## 111599 - 00

**Change Notification #:** 111599 - 00  
**Change Title:** Intel® Desktop Board DQ77KB, Boxed and Bulk  
PCN 111599-00, Product Design  
Capacitor Removal and Change to Customize Front Panel USB Header  
**Date of Publication:** July 12, 2012

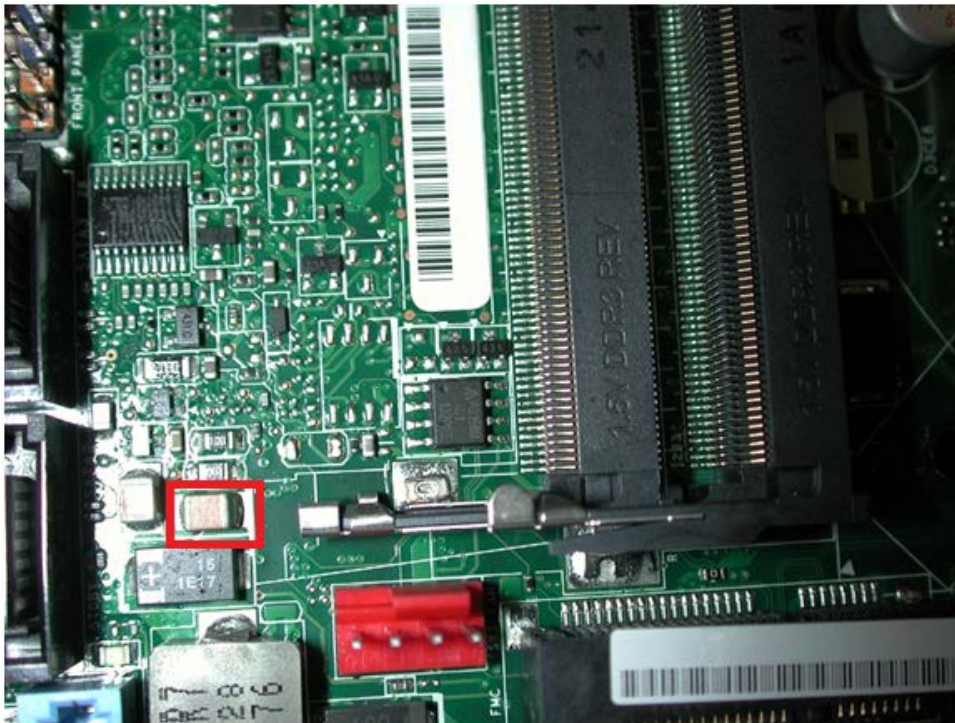
1. One cap will be removed to prevent interference between the capacitor in the memory area and the cap on the edge of the SO-DIMM. [See pictures below.](#)

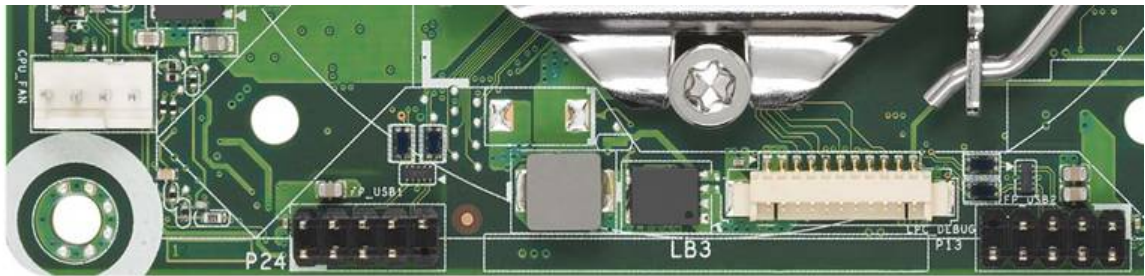
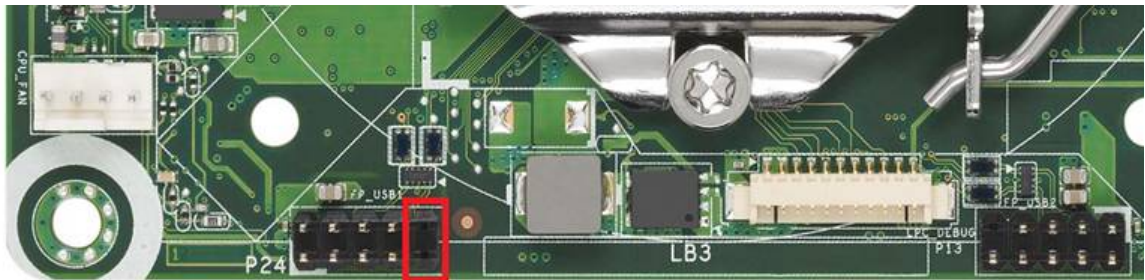
2. The front panel USB header "FP\_USB1" will be updated with a version providing an extra key at pin 10 (previously N/C). **See pictures below.** NOTE: This new header preserves compatibility dual USB cables (one 2x4 cabling) and introduces compatibility with two single USB cables (two 1x4 cables).
